2. I believe that the ministry should undertake my Review to protect the environment because:

#3)a Design of the works

#3)b – Evidence from the Septage Plan Review Prepared for the Municipality of French River by Trow Associates Inc. of Sudbury.

Figure 1, operation of a 2 cell, seasonal discharge, facultative lagoon.

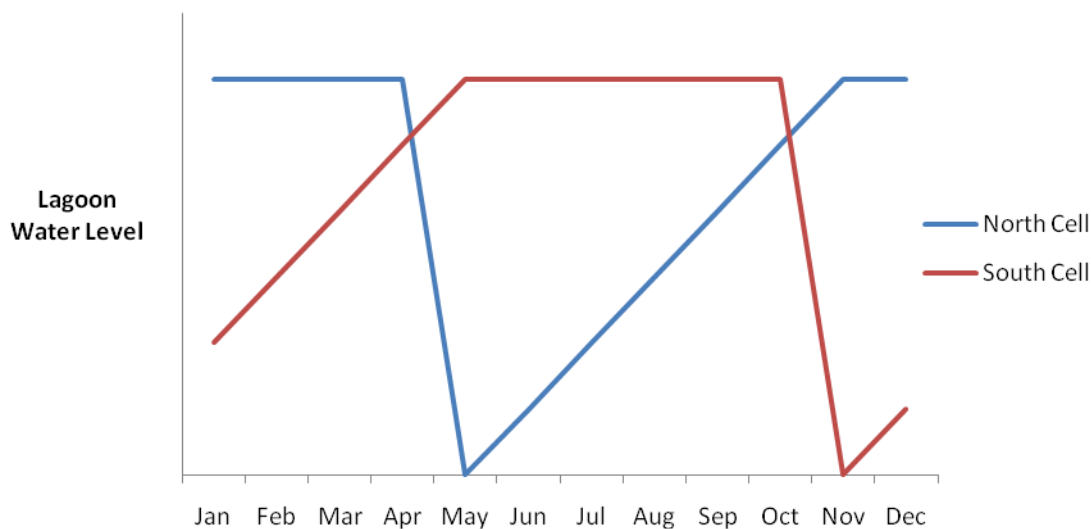
The 300 day retention time is the combined retention time of the two cells, 150 days each. Therefore, each cell is to receive water for half a year (lines segments with +ve slope in figure 1), hold it for 5 months (150 days; line segments with zero slope), then treat and release the contents within a month (line segments with -ve slope) to complete the yearly cycle. When operating on complementary cycles, one of the lagoons is discharged each spring and fall. Combined, the two lagoons are designed to receive a full year's worth of sewage.

The combined volume of the two lagoons is 143,168 cubic metres. Therefore, the average daily flow at maximum capacity is;

$$143,186 \text{ cubic metres per year} / 365 \text{ days per year} = 392 \text{ cubic metres per day}$$

That is the only point I wish to make. However, the Certificate of Approval states that the municipality applied for approval of sewage works with a rated capacity of 477 cubic metres per day. At 477 cubic metres per day the lagoons would be full in 300 days and therefore they would not be able to operate as designed. Consideration of the effect of rainfall onto the lagoon and the reduction in lagoon volume due to sludge accumulation only makes the scenario worse. This error has necessitated the early discharge of a lagoon on numerous occasions, including 3 times in 2008-2009, with retention times as low as 2-3 days. I believe that this mismanagement has had serious negative consequences on the environment downstream.

The error was caused by assuming that the retention time was equal to the filling time, which is true for continuous flow filtration systems but is not true for batch treatment systems such as the French River Sewage Treatment Lagoons. It appears that the 477 figure was arrived at by dividing the volume of the lagoons by the retention time, rather than the filling time. I have explained this to officials at the Municipality of French River, Sudbury East Planning Board, Ontario Clean Water Agency, and the Ministry of the Environment. The responses have ranged from sympathetic to condescending to hostile, but not one official has disputed my calculations or offered an explanation of how the system could operate properly at the rated capacity of 477 cubic metres per day. More than one MOE official has agreed with me that there is a problem but informed me that it wasn't their responsibility.

Figure 2. Operation of Noëlville Sewage Treatment Lagoons. Blue arrows indicate where lagoon contents were released to the environment without adequate treatment time.

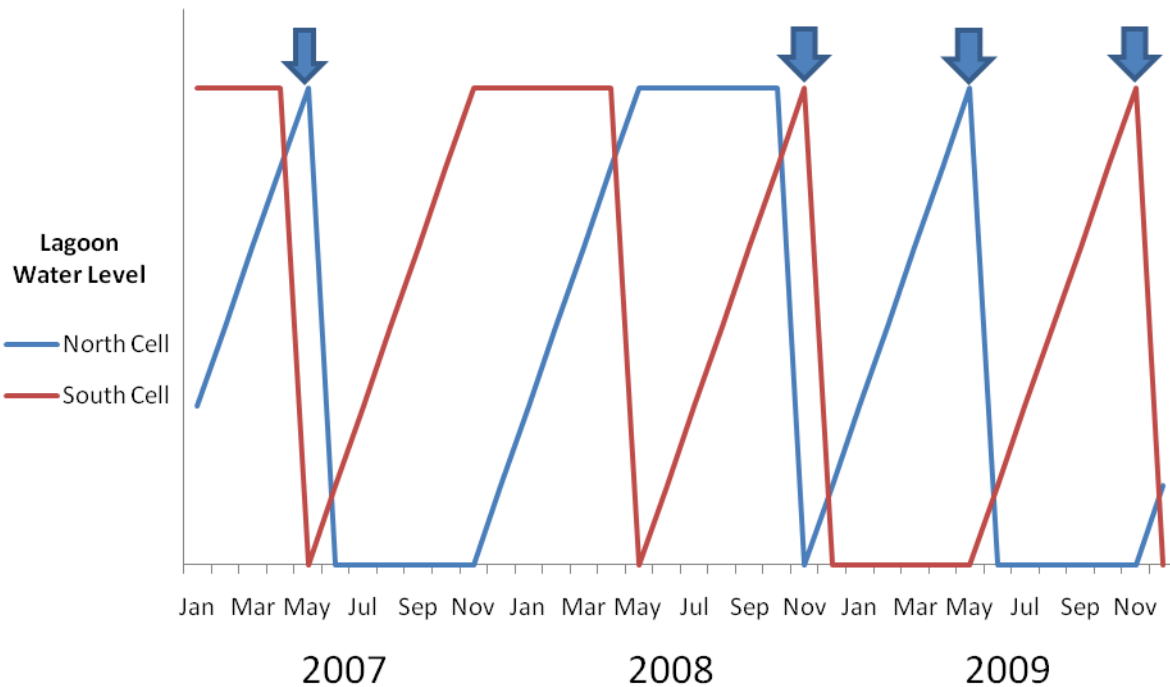
In the April of 2007 there was a bypass of the lagoon and about 300,000 litres of untreated sewage (suspended solids = 94 mg/L; *E.coli* = 700 cfu/100mL) was discharged to the river. In addition, both of the lagoons were drained down that spring, which resulted in approximately 70,000,000 litres of sewage from the South lagoon being discharged with inadequate retention time. In fact, from May 14-16, 2009, both lagoons were being discharged at the same time. About 1,000,000 litres of sewage passed through the system during that period. Sewage must be held in the lagoon for months to allow for biological processes to properly treat the waste. The reason that effluent levels are low in the south lagoon discharge is because large amounts of rainwater infiltrated the system and diluted the contents, not because the sewage was properly treated. Dilution is still pollution.

There was no release of the lagoons in the fall of 2007 and the south was drawn down in the spring of 2008. In the fall of 2008, both of the lagoons were released again, with a minimum retention time of 2 days to 2 weeks for the south lagoon. The south lagoon discharge exceeded MOE effluent limits for suspended solids by >30% and had *E. coli* levels of 280 cfu/100mL in the 42,252,000 litres of effluent discharged.

In 2009 the lagoons were both released without adequate retention time. The north lagoon, which began filling in November of 2008, was filled until April 2009 and promptly released into the river in May. In a meeting I had with Municipal Councillor Ron Garbutt and representatives of OCWA in April 2009 Mr. Dave Walters, operations manager for OCWA, agreed that it would be preferable to let the lagoon sit for the summer but was worried that there was not enough capacity to hold the water until the fall. It was agreed that the North lagoon would be discharged only if further analysis by OCWA determined that there indeed was not enough capacity to hold and treat the water. The lagoon was subsequently discharged in May without adequate treatment, confirming that the volume of sewage that it was receiving was too much for the lagoon to handle. The south lagoon was then filled from May through the summer and then discharged prematurely in October of 2009, well before the 150 day designed retention time. The average daily flow into the lagoons for 2009 was reported by OCWA to be 523 m³/day, which is 110% of the 477 m³/day design capacity stated in the Certificate of Approval and 133% of what I believe to be the true capacity of 392 m³/day.

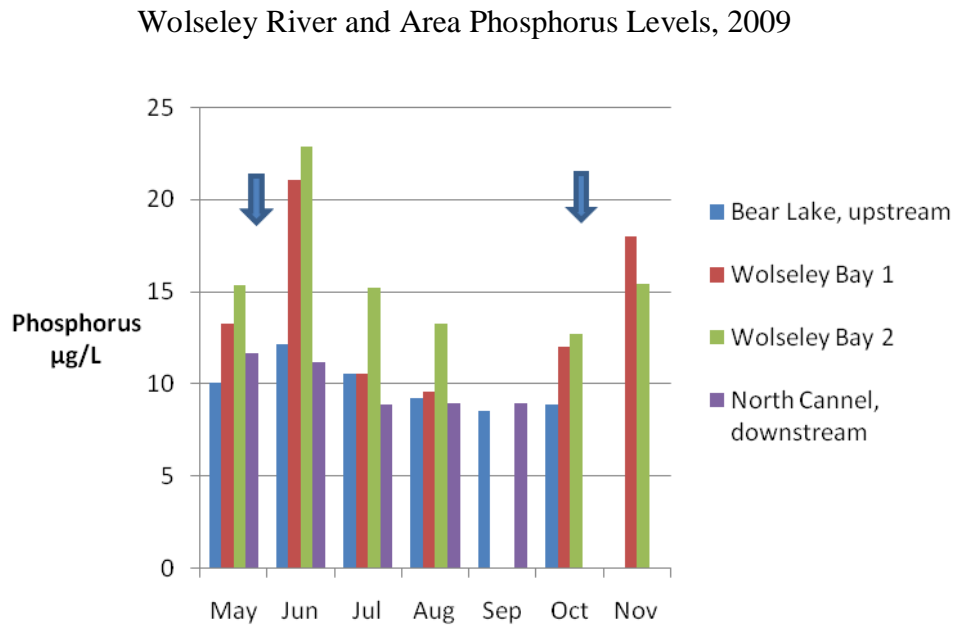
I have been collecting samples for determination of phosphorus levels by the Ontario Lake Partners Program since 2007. Elevated phosphorus levels are consistently found in Wolseley Bay of the French River, which is the first 'large' body of water downstream from the Noëlville sewage treatment lagoons. In 2009 I recruited a volunteer to collect samples in Bear Lake, which is the last lake on the Wolseley River system upstream of where the sewage treatment lagoon discharge enters the river. The data are summarized in the graph below and show that phosphorus levels spiked in Wolseley bay following the two lagoon discharges (represented by blue arrows).

This disproportionate increase in phosphorus levels in Wolseley Bay following lagoon discharges is consistent with a cause and effect relationship whereby effluent releases from the Noëlville Sewage Treatment Lagoons contribute to the elevated phosphorus levels in Wolseley Bay of the French River.
